Questions and comments of the reviewer 3 are in bold

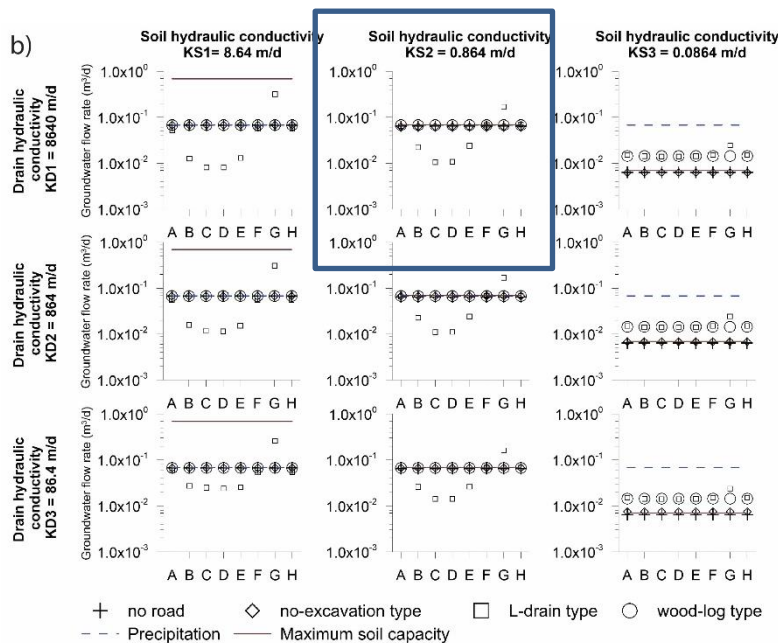
However, I still not really see the connection of the tracer test and modelling. I agree that a quantitative coupling (e.g. comparison of simulated and observed concentrations) will be very challenging caused by parameter heterogeneities, which are difficult to capture. Also, I can somehow agree to the argument that you want to provide a general modelling framework. However, this leaves me with the question: Why you Discussion paper incorporate the tracer test at all? How does it support your synthetic model? Besides showing natural heterogeneities, you just prove that a L-drain constitutes a preferential flow path. Isn't that a bit too trivial?

Finally, it is clear that below the road and immediately downgradient, the L-structure create a preferential flow path. However, the key question is how quickly flow redistributes again laterally further downgradient. With the suggested modifications (described in the next section), this question can be answered.

Simulated groundwater velocities 2 m downstream each road structures and each parameter combination with a slope 20%.

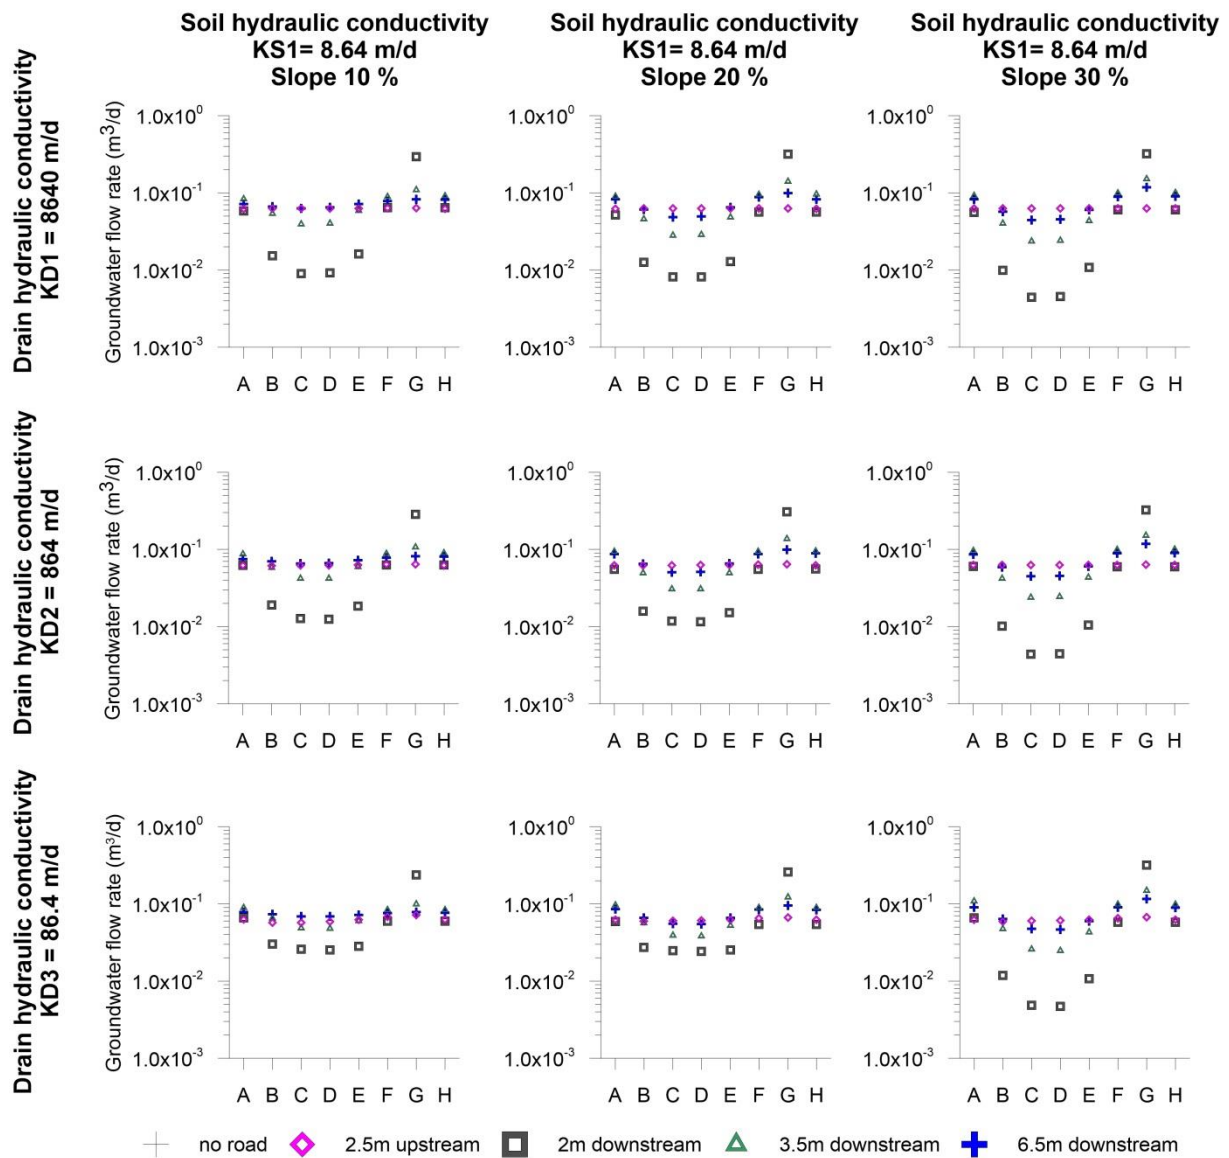
In addition, section 3 will be reworked and new subsection will be added in which we assess the potential risk of gully erosion. To achieve this, the simulated groundwater flow rate will be compared with the maximum flux than can flow in the soil calculated with the Darcy law. If the road structure induces a groundwater flow higher than the soil capacity then gully may occur. For example in the surrounded plot in Figure below, you see that L-drain induces a groundwater flow rate higher than the soil capacity and therefore may induce gully erosion.

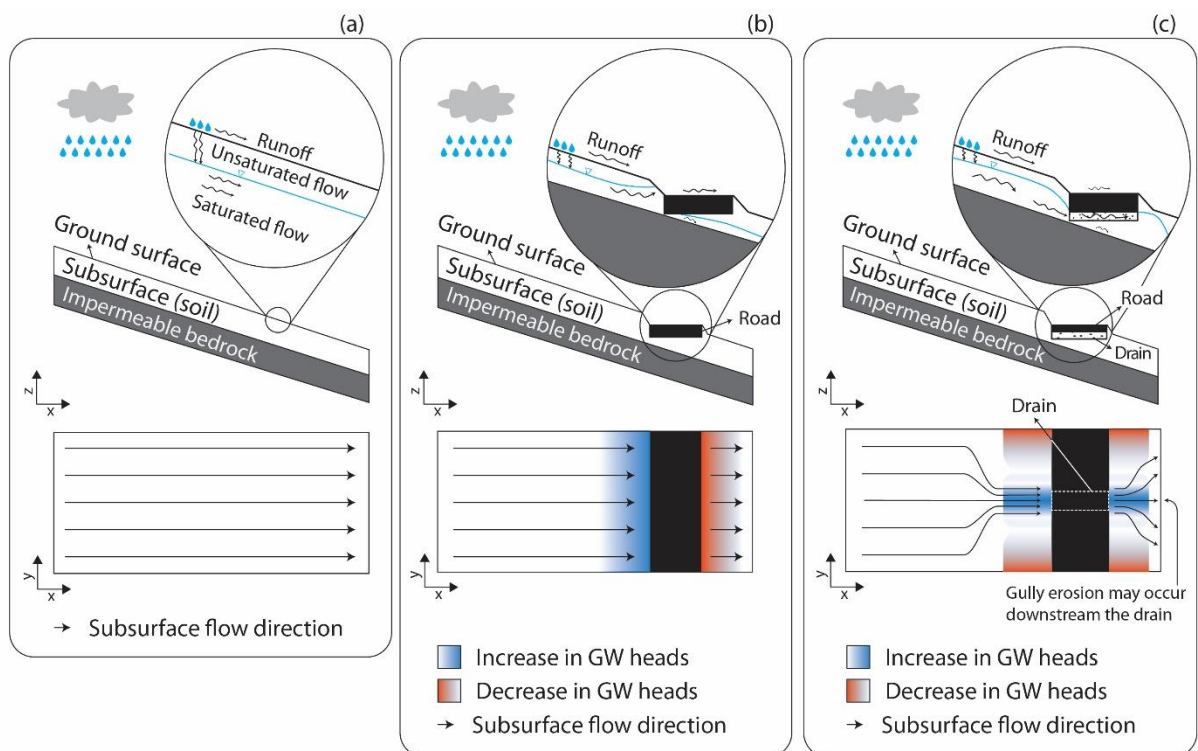
Figure 1: The cross-sectional view suggests that the water could easily pass underneath the road. However, in the text you mentioned that the top soil is very thin so that the road blocks the water flow to a large extent (also indicated by the lower figure). Isn’t the figure a bit misleading? I would just increase a bit the size of the road and additionally sketch the impermeable bedrock.

The size of the road in the figure 1 was increased and impermeable bedrock was added. In this way, the reader will directly understand that the groundwater is blocked upstream the road.

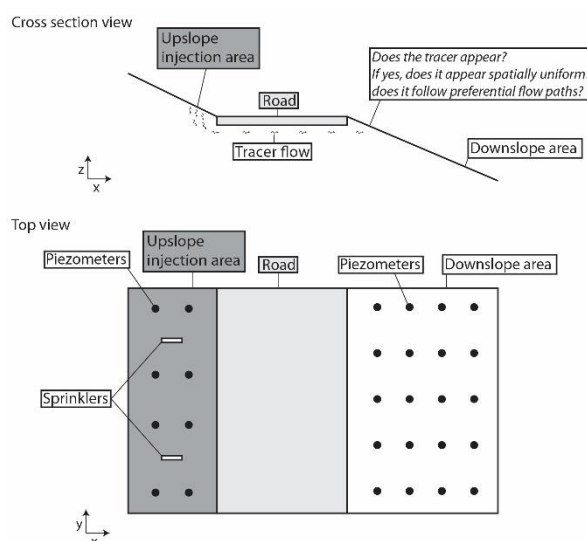
Figure 3: For me, the cross sectional view is a bit superficial, but I guess this is a matter of taste: Still, the spaces before the question marks should be deleted. Moreover, I would just write “Piezometer” instead of “Mini-piezometer”.

The figure 3 was modified according to your comments.
